**Re: InnPower Corporation
2017 Rate Application (EB-2016-0085)
Response to Interrogatories**

INNPOWER CORPORATION

EB-2016-0085

RESPONSE TO INTERROGATORIES
Pole Attachment Charges

Figure 3 Age Profile of Wood Poles in Different Heights

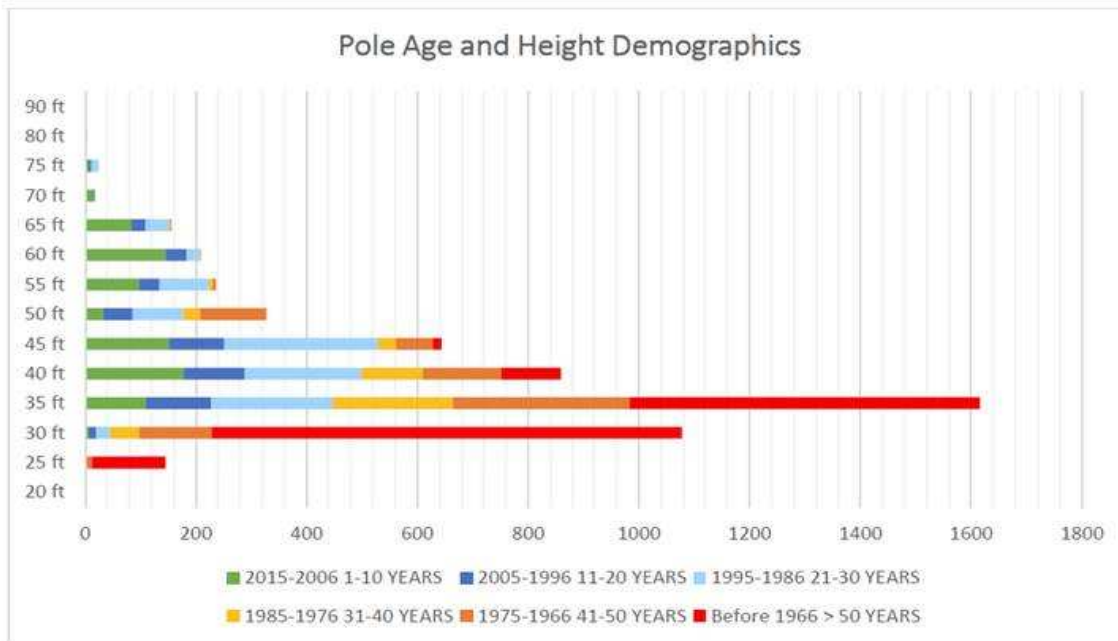
3. As InnPower responded to 8-Rogers-4 part 3, InnPower cannot provide a complete listing of the information requested due to the transition of GIS systems. Detailed information on the height, age and condition of InnPower's poles can be reviewed in InnPower's Distribution System Plan – Appendix E- Distribution Asset Condition Assessment Section 4.1.1 Distribution Wood Poles. The following is an excerpt from Appendix E addressing the height, age and condition of InnPower's poles. Appendix E – Distribution Asset Condition Assessment has been enclosed in this response.

4. The circumstances dictating the height of a pole are dependent on the distribution servicing requirements in alignment with the USF Standards – DWG NO. 11-103 Joint Use Pole Separation and Location.
5. InnPower can confirm that the capitalized costs associated with the replacement of an InnPower pole with or without attachments is included in Account 1830. InnPower can provide a total value of additions and disposals for the years 2014 - 2016 but cannot provide the associated costs only due to pole replacements in the time allocated for the IR responses. The following table provides the costs in Account 1830 for additions and disposals for the requested years.
